IREDELL COUNTY HEALTH DEPARTMENT

IMPROVEMENT PERMIT / AUTHORIZATION TO CONSTRUCT / OPERATION PERMIT / EXISTING SYSTEM INSPECTION

PERMIT# 083838 PIN# 4717 73 9917

INITIAL SITE SKETCH

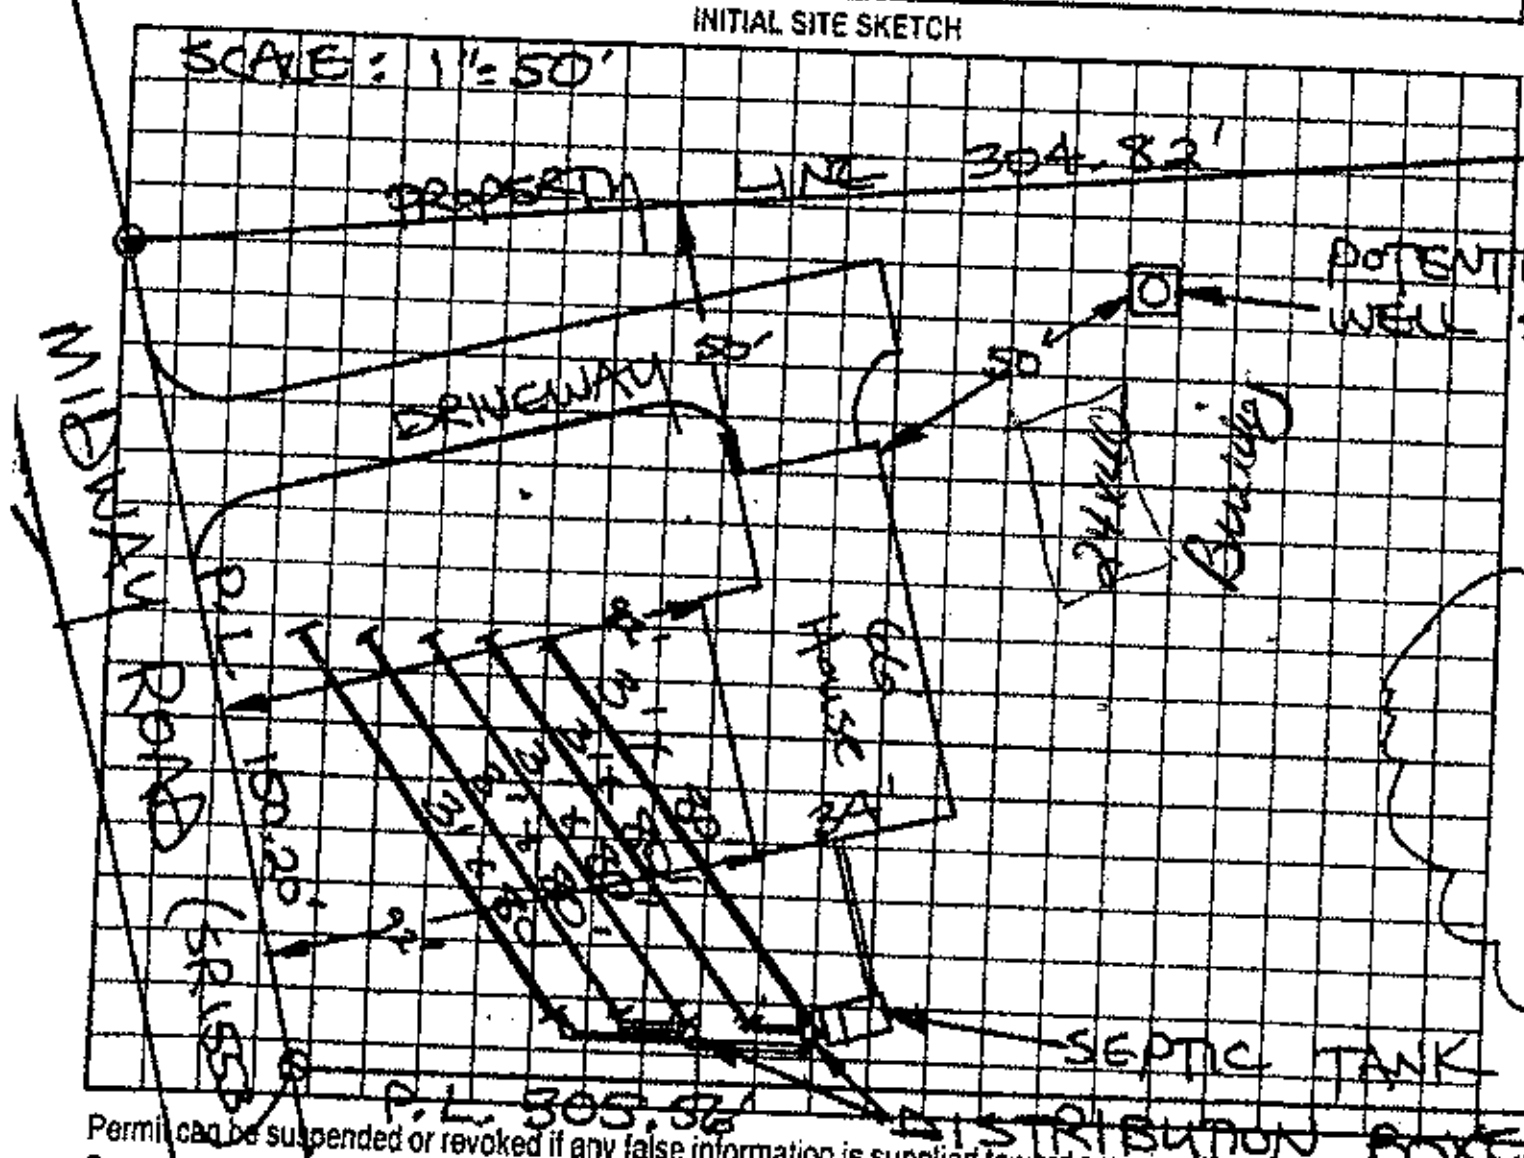
Comments/Conditions: KEEP SYSTEM MINIMUM 100 FEET FROM WELL

Comments/Conditions: SEPTIC TANK W/ RISERS INSTALLED USING "POLYLOK" FILTER

AS BUILT SKETCH

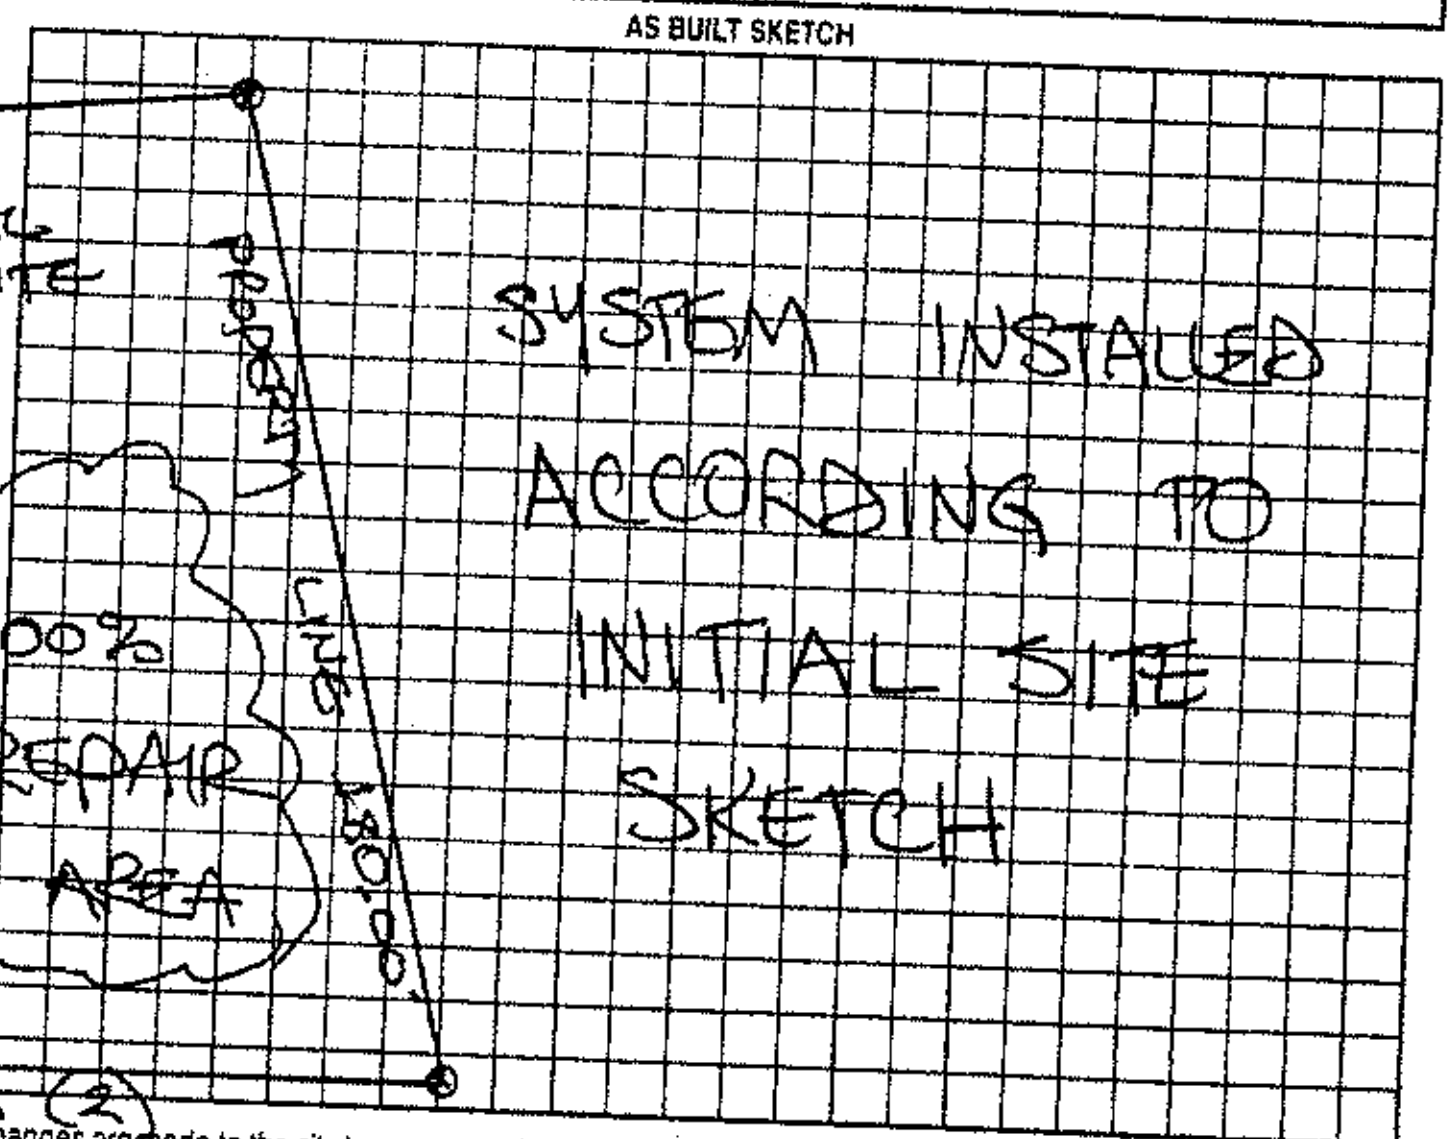
Location of the proposed Accessory Building **addition does not appear to impact the existing ~~on-site~~** Well **septic system.**NOTE:** NEEDS to be 25' minimum from
